Product Change Notification

109995 - 01

Change Notification #: 109995 - 01
Change Title: Intel(R) Server Board S3420GPLX, S3420GPLC, S3420GPV, S3420GPRX and Intel(R) Server System SR1630GP, SR1630HGP, SR1630GPRX, SR1630HGPRX, PCN 109995-01, Product Design, Update BIOS, change WEEE logo location and remove CCC mark, Reason for Revision: change WEEE logo location and remove CCC mark
Date of Publication: May 21, 2010

The following is a picture of the old Regulatory Label:

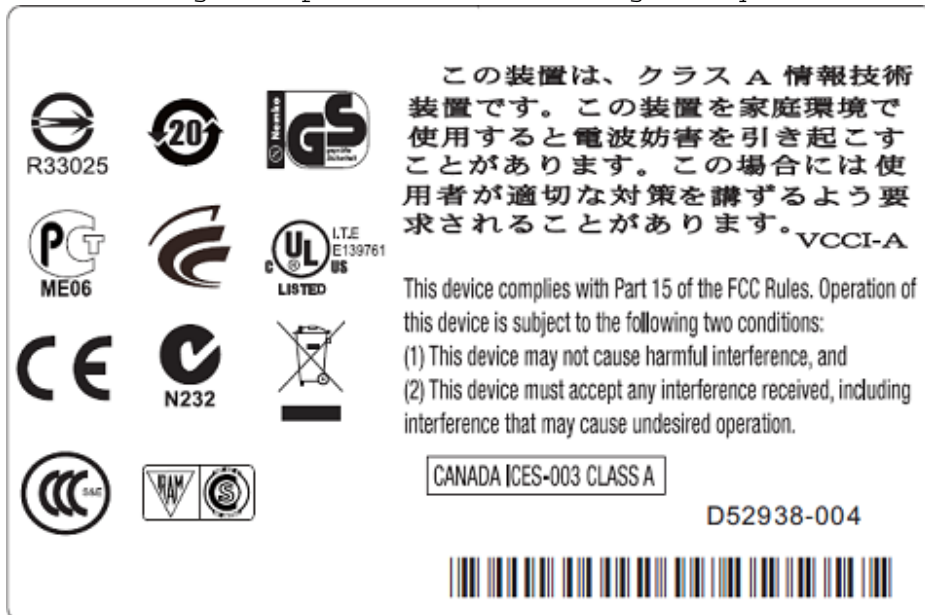
3. Updating the Regulatory Label on the Intel (R) Server System SR1630GP, SR1630HGP, SR1630GPRX and SR1630HGPRX packaging box to remove China Compulsory Certification (CCC) mark and Waste Electrical and Electronic Equipment (WEEE) mark.
